PROJECT: COLORADO & 4TH STATION

RFI No. 9R1

Subject: Design Energy Demand Summary

C/S Building Roof Plan:

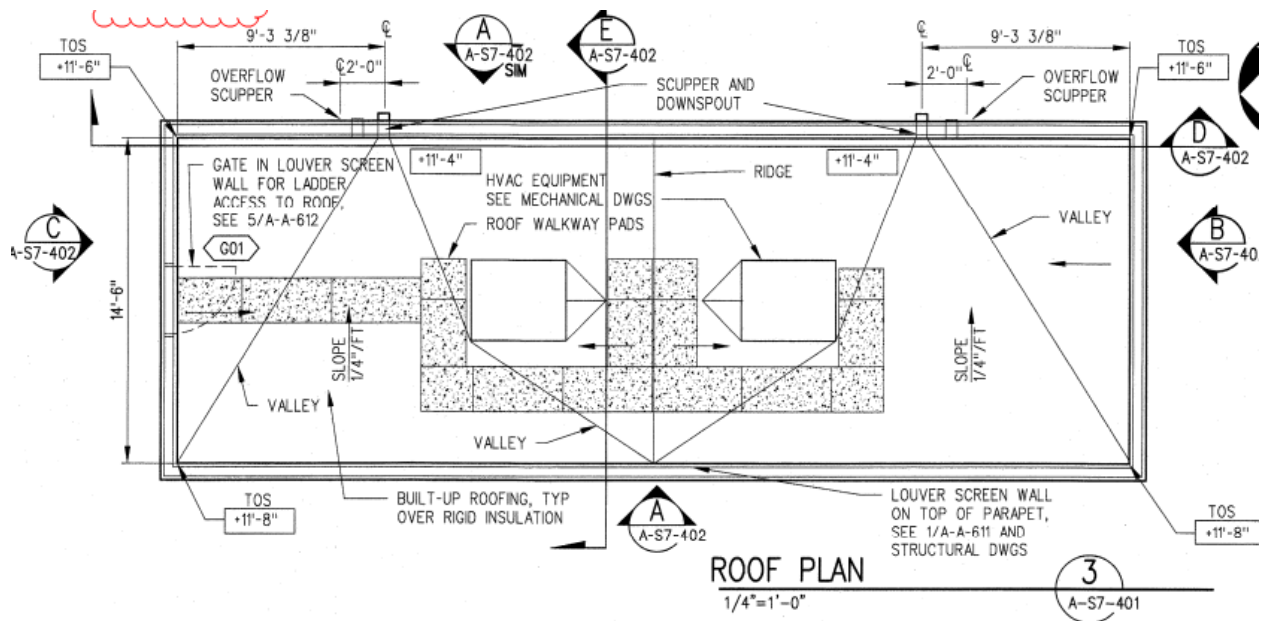
The design energy demand summary cannot be found in the drawings. Please provide the summary, or what sheet it is located on.

See Additional Information.
